**2.3.2 AMENDMENT 14: CPL**

**Louvres extended to underside of level 00M slab**

APPROVED ELEVATION  
Drawing: 19556-CPA East Elevation

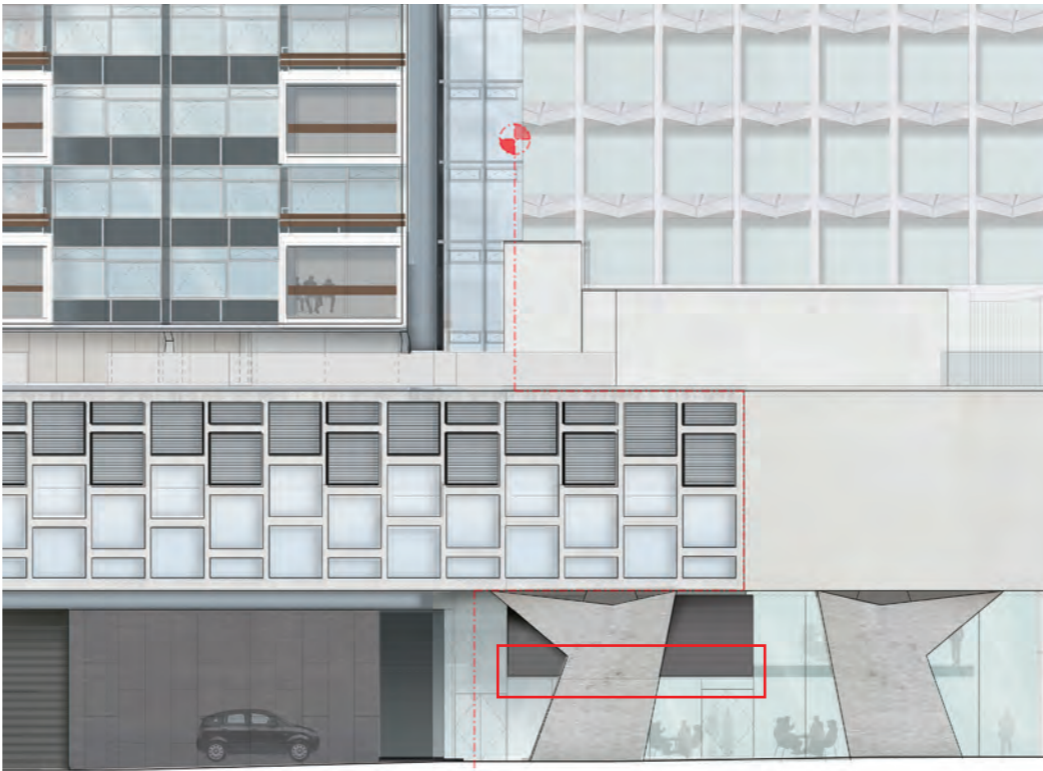
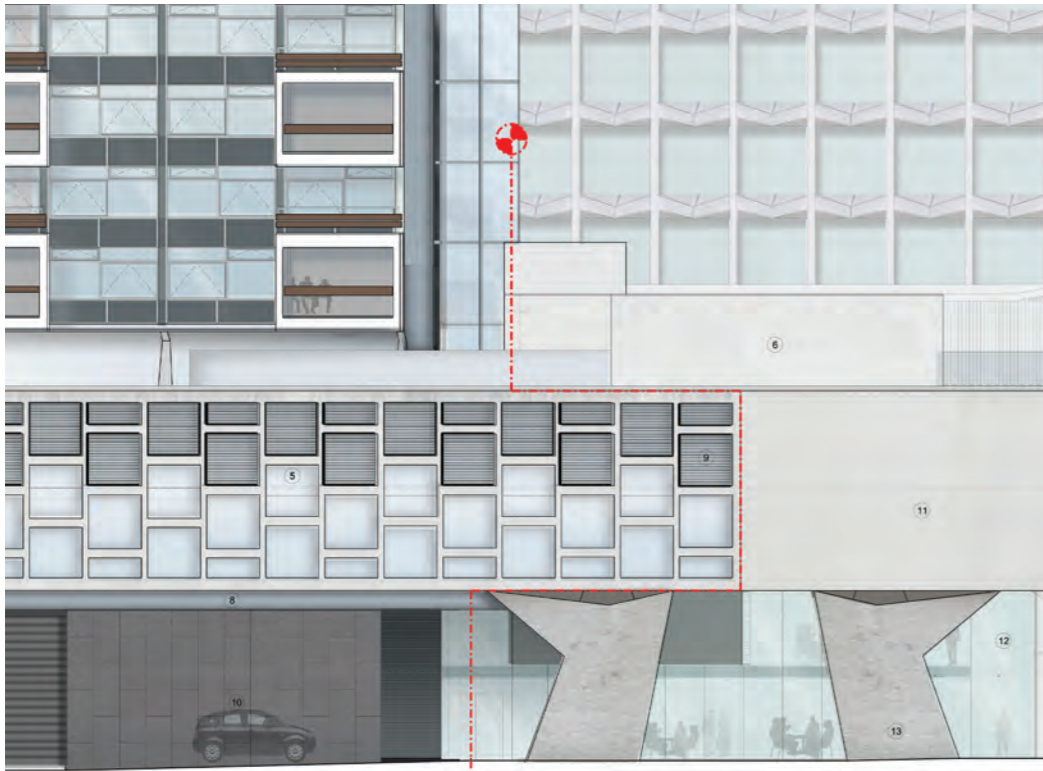
Following stage E design development, there was a requirement to provide a structural movement joint in the East facade running along the underside of the mezzanine slab. It was felt that this joint in the facade would be visually unsightly, breaking the continuous facade plane, particularly when viewed from pedestrian level. Therefore, in order to conceal this, it is proposed to extend the louvres down by approximately 350mm to the underside of the existing mezzanine slab. The joint is then concealed within the louvre / glass junction.
